Your ref: APP/X5210/W/22/3291816

Our ref: 2021/3649/P Contact: Enya Fogarty Direct line: 020 7974

Planning Appeal by Ms Kristen Charnley Site: 49 Pratt Street London NW1 0BJ

Appeal against the refusal of planning permission for 'Erection of wooden trellis to create a first floor terrace.

Proposed section showing the depth of the terrace granted under 2017/5151/P

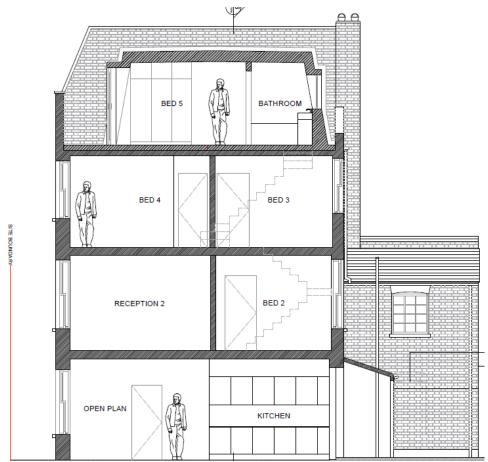
1. The appellant provides examples of similar type of developments the council has granted. It should be noted that the council does not object to the principle of a terrace but the design, location and size of the proposed terrace subject to this appeal. The first example is a front terrace granted under planning reference 2017/5151/P on 4<sup>th</sup> December 2017(see below) at 51 Pratt Street. The appellant states this terrace is in a 'much higher and more prominent position compared to that which is proposed in this application.' Although the terrace is located to the front of the property and located within the roof, due to the parapet wall, the terrace is hidden and not highly visible from the streetscene or neighbouring properties. Additionally the depth of this terrace is much smaller than the terrace proposed at the appeal site.

Proposed section showing the depth of the terrace granted 2004/1287/P

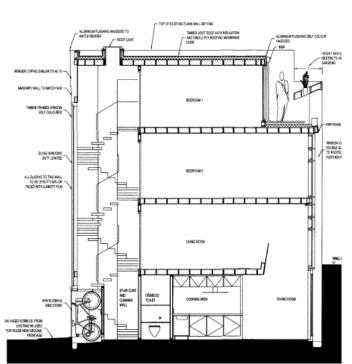
2. The applicant's second example relates to a rear balcony granted under 2004/1287/P at 9a St Martins Close. The applicant states a similar argument that this balcony is in a more prominent position of the proposed terrace subject to this appeal. Although this terrace would be located in a higher position, this terrace is also hidden by a parapet wall which reduces its visibility and is more of a sensitive addition to this property then the terrace proposed (see below). Additionally again this terrace is smaller in size and depth than the one subject to this appeal.

Proposed visuals showing the height of the trellises creating a box like addition to the rear of the property

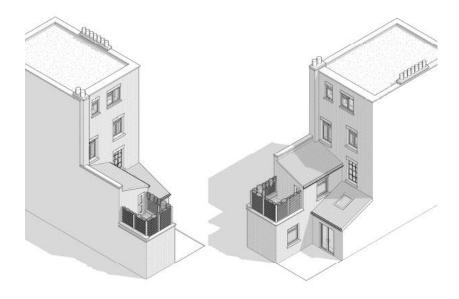
1. The council agrees that the proposed terrace would not be visible from streetscene but the terrace would be visible from private vantage points of neighbouring properties. Furthermore the council disagree that the trellises would not have appear as a permeant structure, the trellises would remain in situ for amenity reasons and would surround the entire terrace. As a result the height, bulk and construction of the terrace it would be perceived as a bulky, incongruous addition (see below).
